To: All Vendors  
From: Seletha R. Thompson  
Purchasing Analyst  
Re: **Addendum #1 for RFP 21305 - Luis Munoz Marin**

# **ADDENDUM**

***Cleveland Metropolitan School District***  
**Luis Muñoz Marín Elementary School**  
**AC-5 RTU Replacement Project 2020**

July 20, 2020

DRAWING NUMBER:  
**M.01**  
 PAGE: 2 of 10

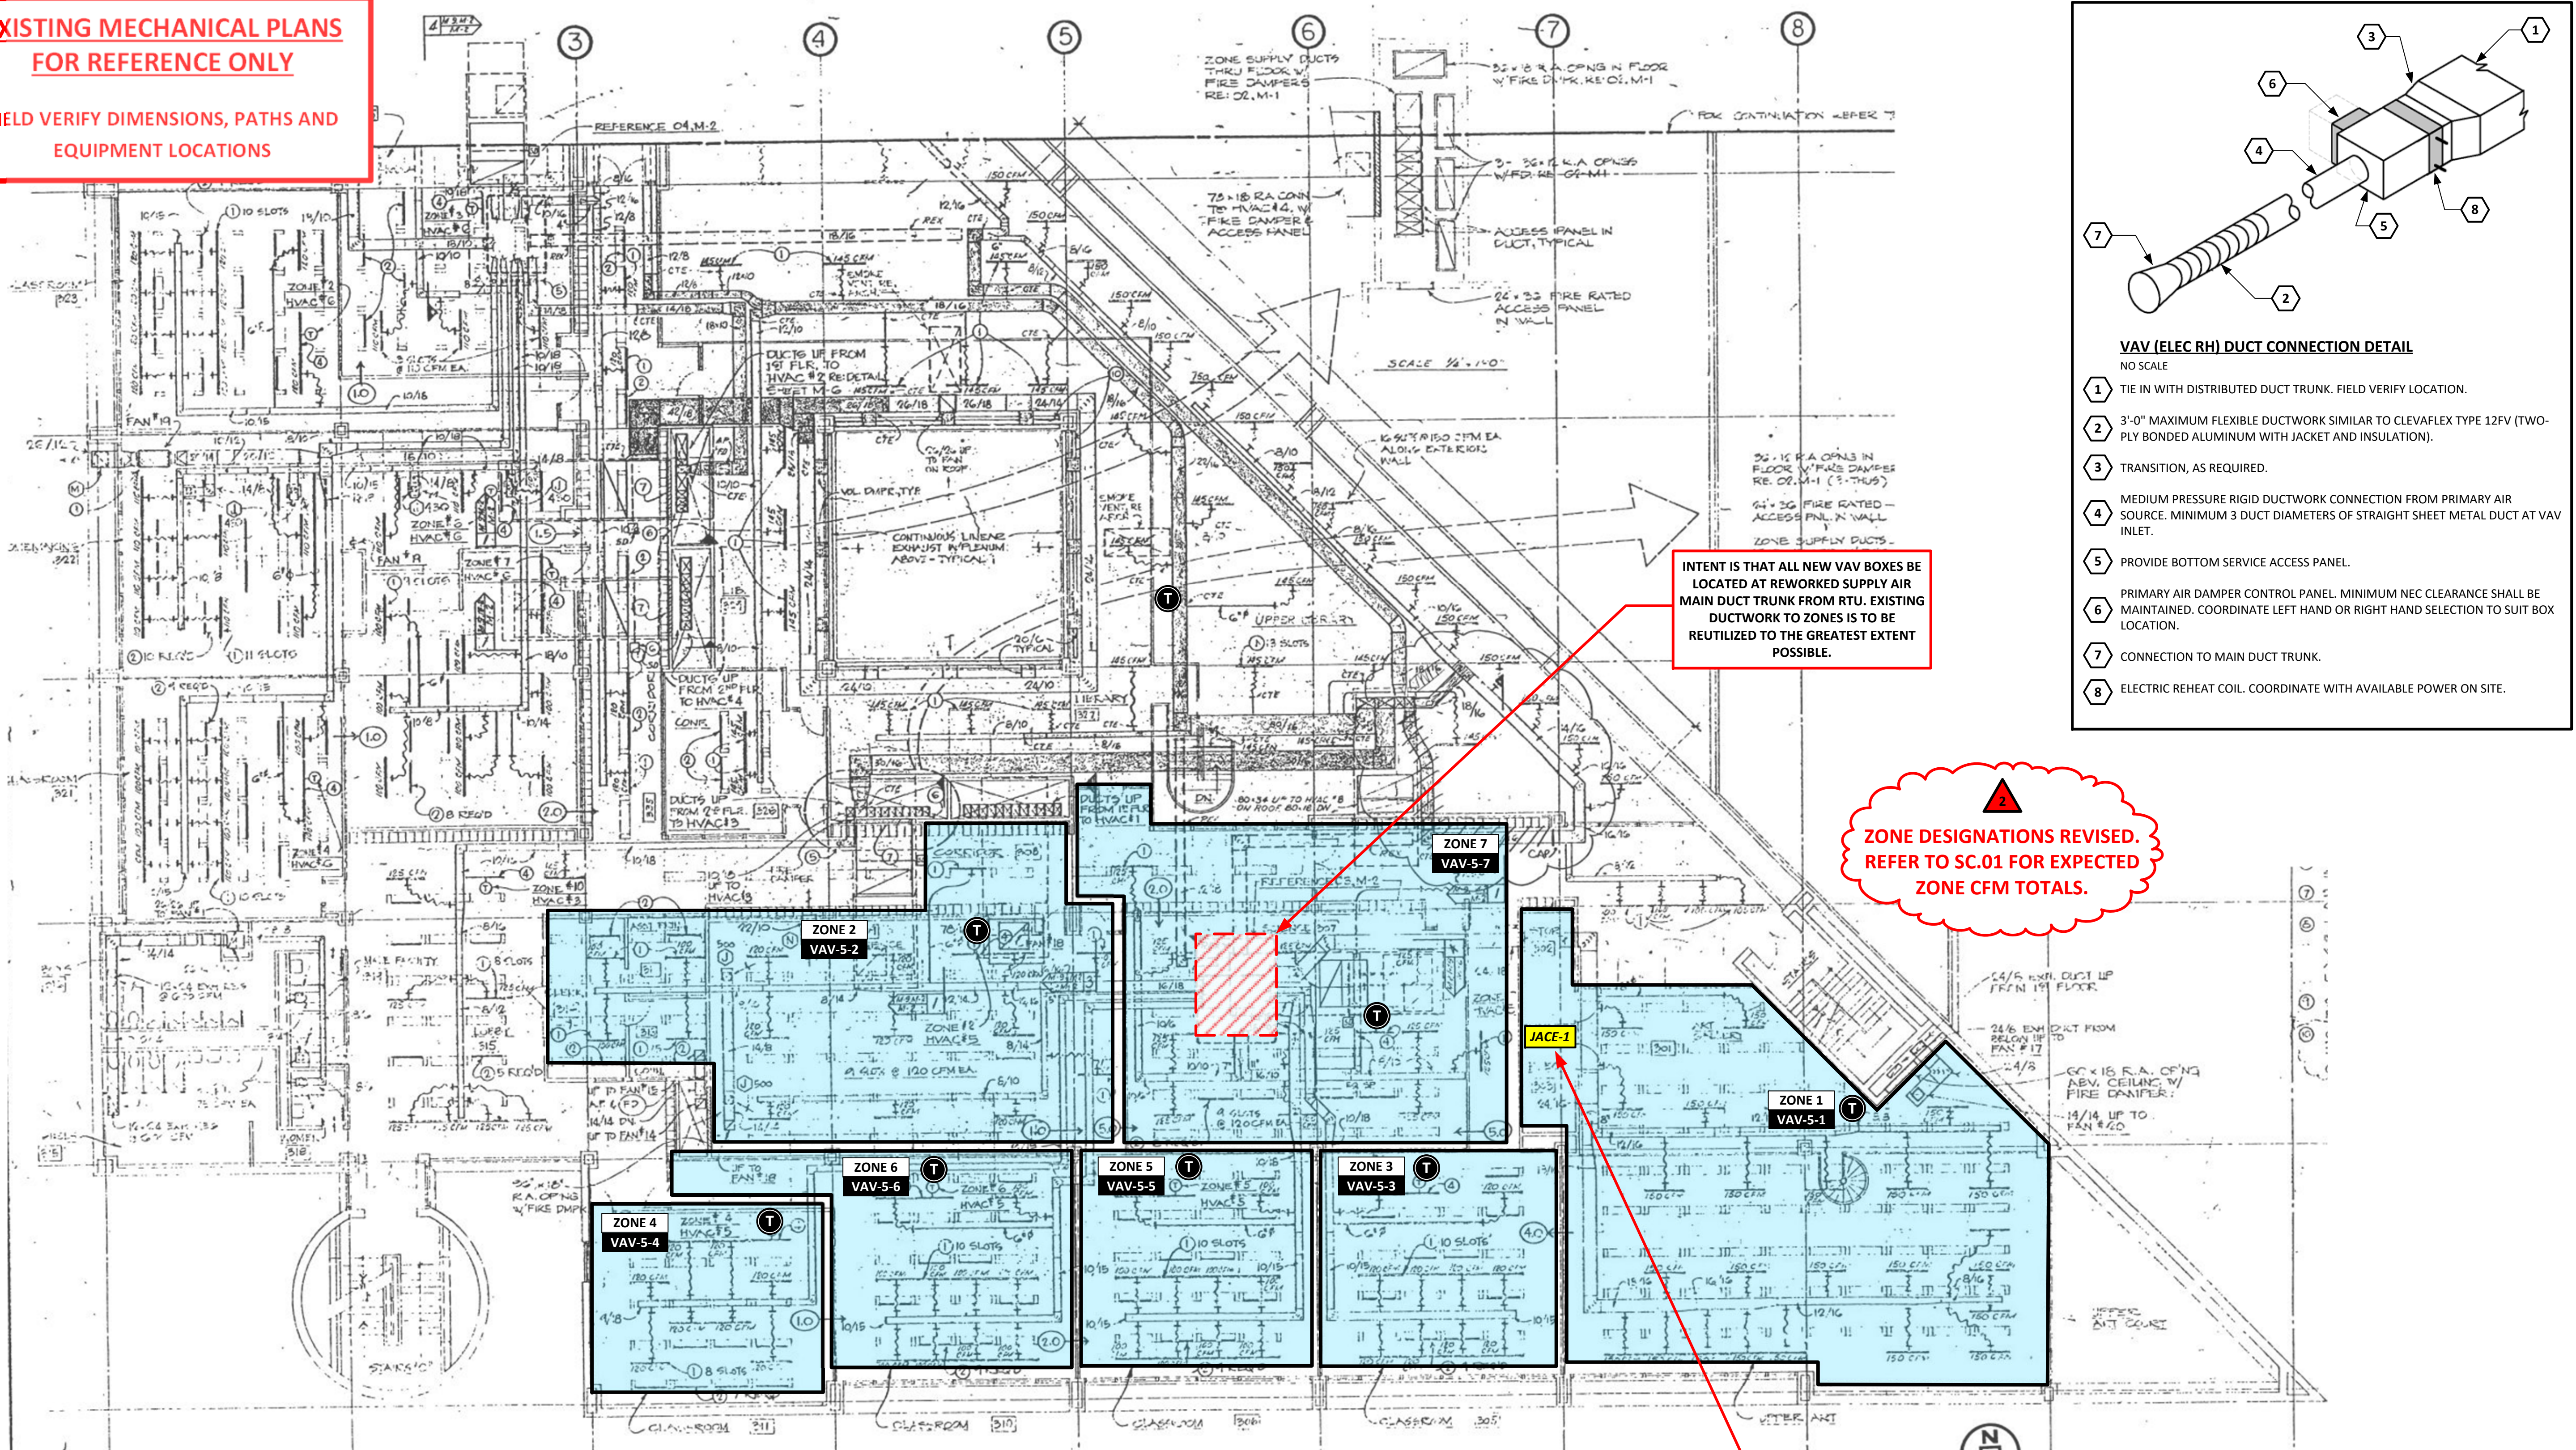
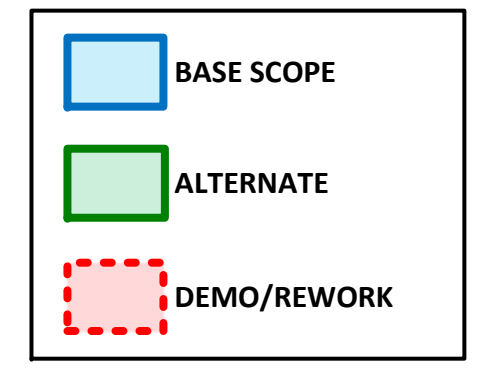
- Sheet M.01 (Page 7):
  - Added note to refer to added sheet SC.01 for revised zone CFM totals and VAV schedule.
- Sheet M.02 (Page 8):
  - Revised HVAC Zone Designations in accordance with sheet SC.01.
- Sheet A.01 (Page 9):
  - Revised Lighting Zone Designations.
- ADDED Sheet SC.01 (Page 10):
  - Contains RTU HVAC Unit AC-5 zoning schematic, CFM totals and revised VAV schedule.

REFER TO SHEET SC.01 FOR REVISED ZONE CFM TOTALS

**M.02**

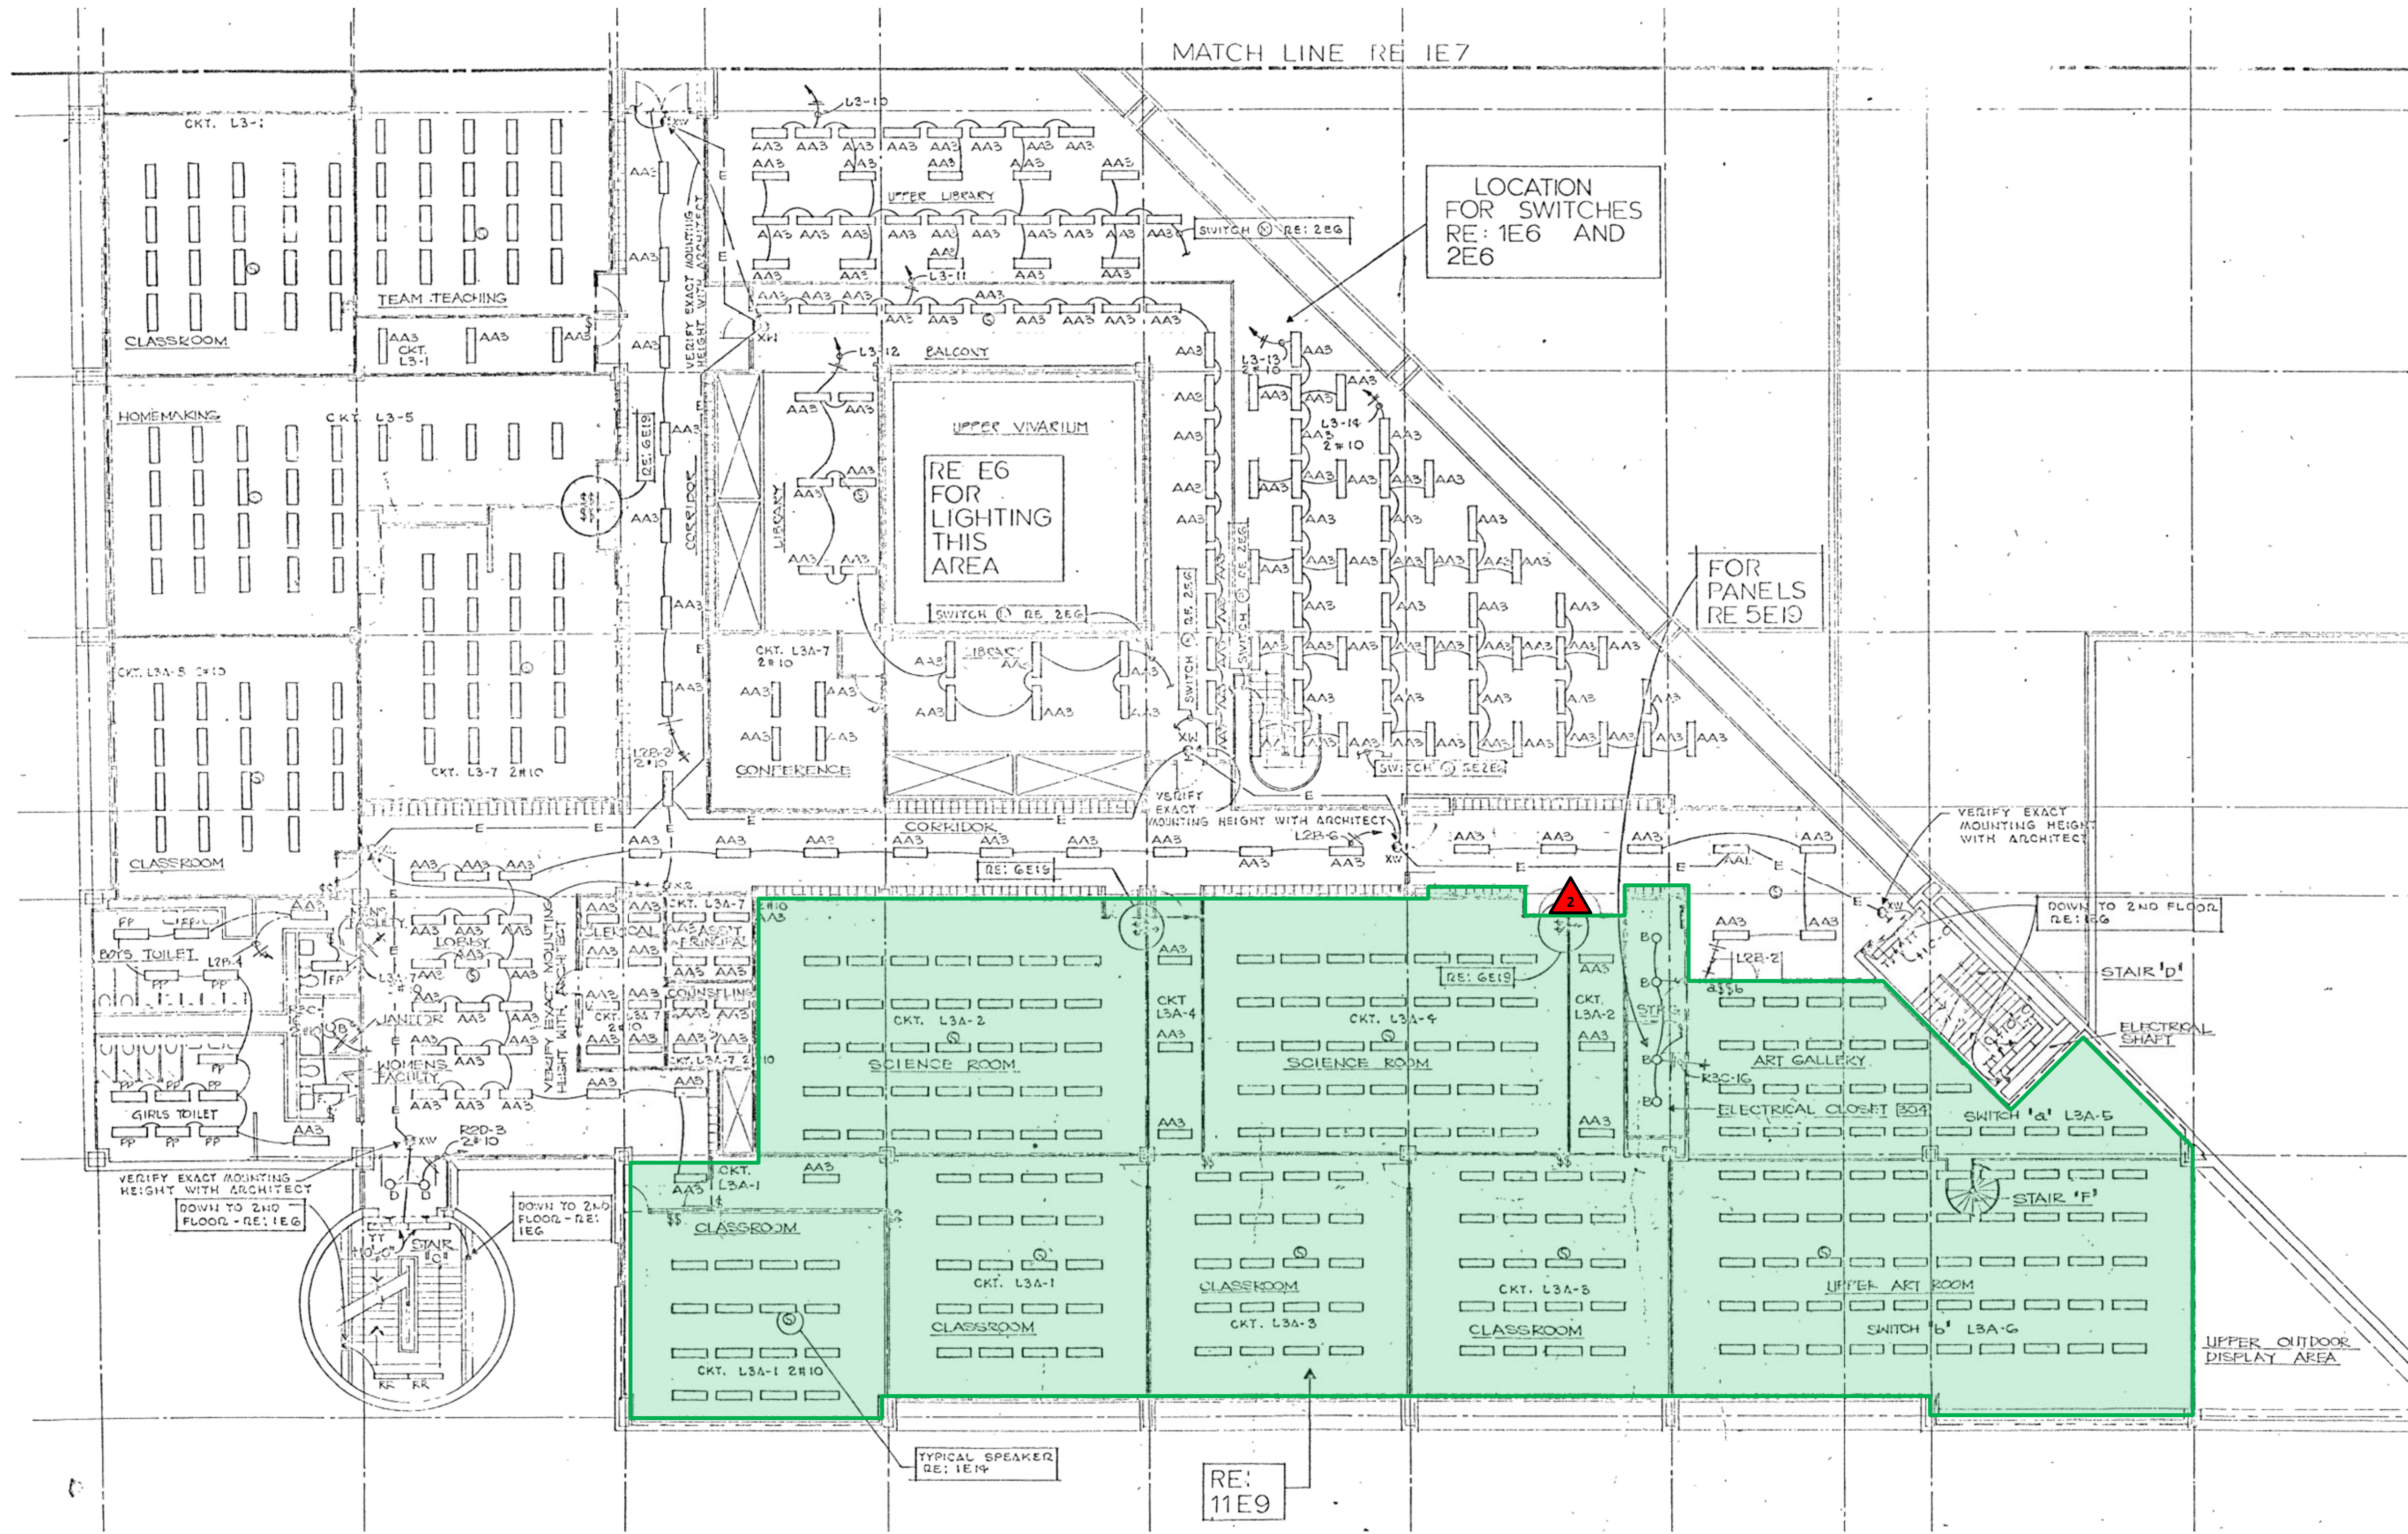
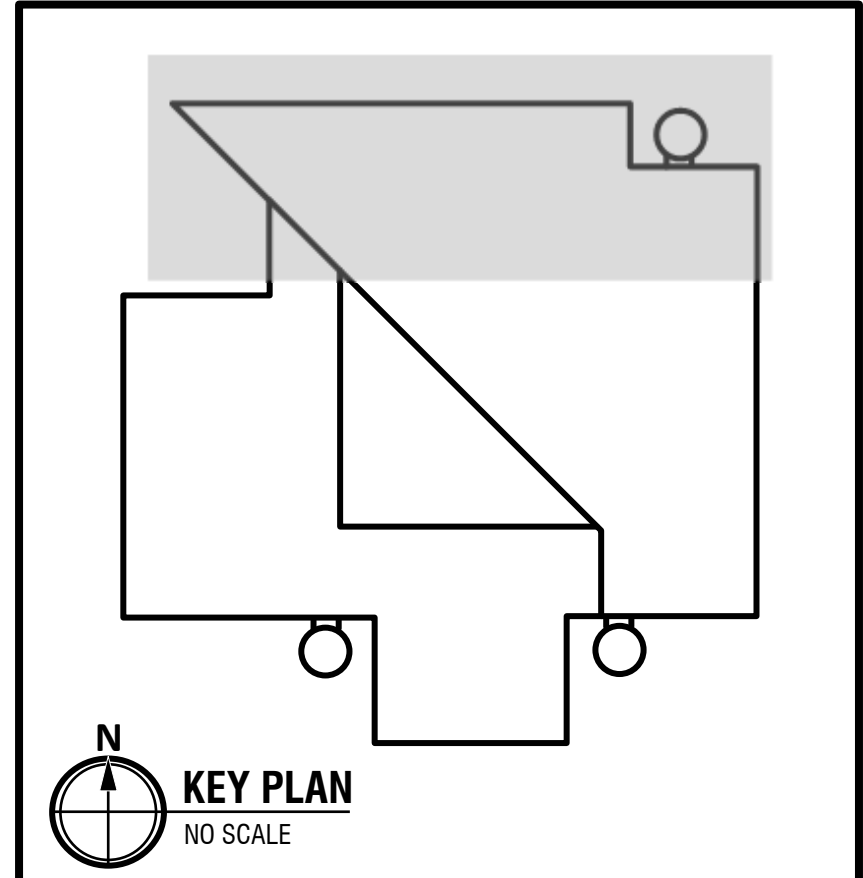
ZONE DESIGNATIONS REVISED. REFER TO SC.01 FOR EXPECTED ZONE CFM TOTALS.
